NOTICE OF
ADDENDUM NO. 4

PROJECT NAME: Gillette Trunkline (Genesee Segment) Drainage and Paving
Improvements

PROJECT NO: WBS No. M-410290-0003-4

ADDENDUM NO. 4

GILLETTE TRUNKLINE (GENESEE SEGMENT)
WATER AND SANITARY PLAN AND PROFILE SHEETS
GENESEE STREET
STA 8+00 TO 12+50
ADDENDUM NO. 4

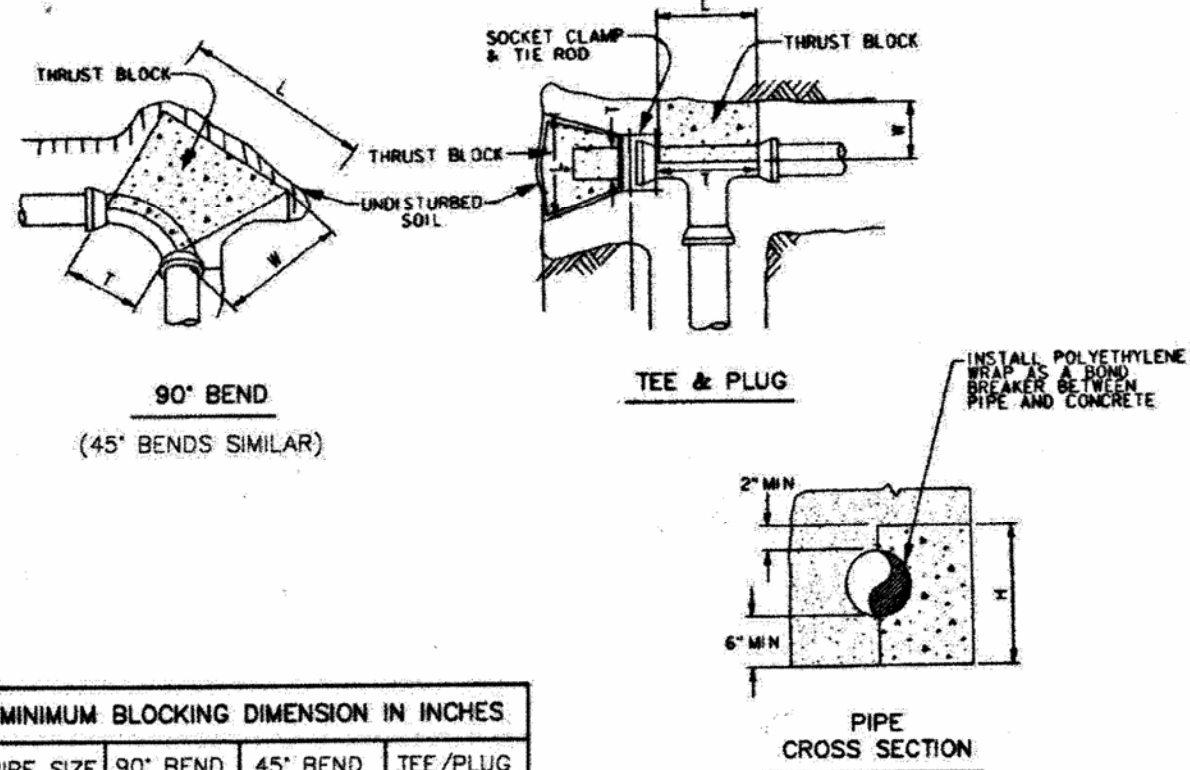
1. Drawing No. 44 – Water and Sanitary Sewer Plan and Profile Sheet, Genesee Street Sta 8+00 to 12+50. Replace entire document. Reason – Removed Conflict Manhole Callout.
2. Drawing No. 65 – COH Standard Water Line Details (2 of 2). Replace entire document. Reason – Removed Casing Detail.

2 CASING DETAIL
(FOR WATER MAINS LESS THAN
36-INCHES IN DIAMETER)

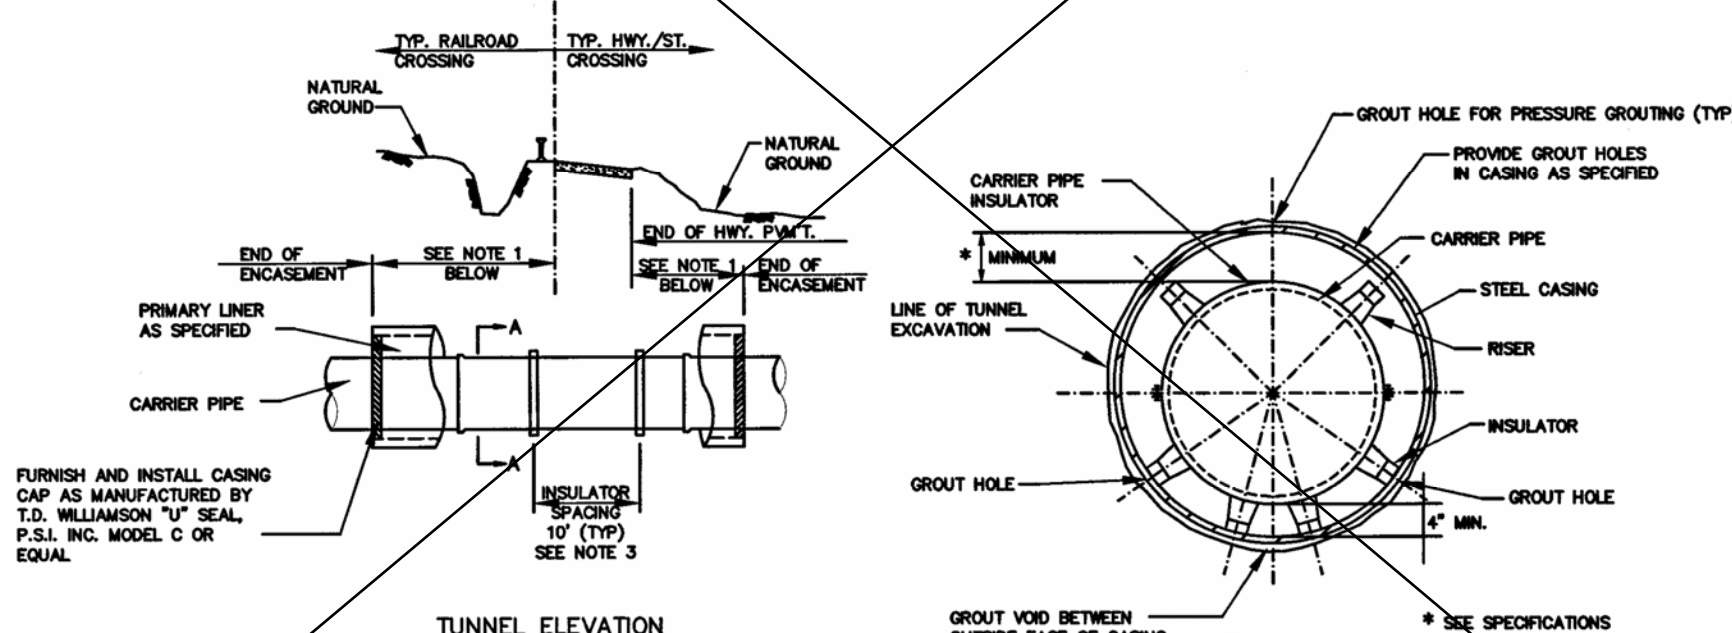
Q1.	Is casing/liner required for trenchless construction of water bid items 147, 148, 154, 155, 156, 157, 160, & 161? If required, detail 2/37 on sheet 65 shows a casing schedule for water line segments not located in this plan set. Can a casing/liner schedule be provided?
A1.	<i>Casing/liner will not be required. Detail from sheet 65 has been removed.</i>
Q2.	Sheet 44 calls for the installation of MH-G11A (conflict manhole) at station 9+40. MH-G11A is not shown on plan or profile. If a conflict manhole will need to be installed, can the owner provide a detail of the manhole? Also, please clarify what the manhole is in conflict with.
A2.	<i>Conflict manhole will not be needed and callout has been removed from drawing.</i>
Q3.	Will the owner and engineer allow the contractor to leave a temporary driving surface in place between the utility relocation phase and box culvert installation phase?
A3.	<i>Yes. Please see Traffic Control Plans for locations where temporary pavement is anticipated.</i>
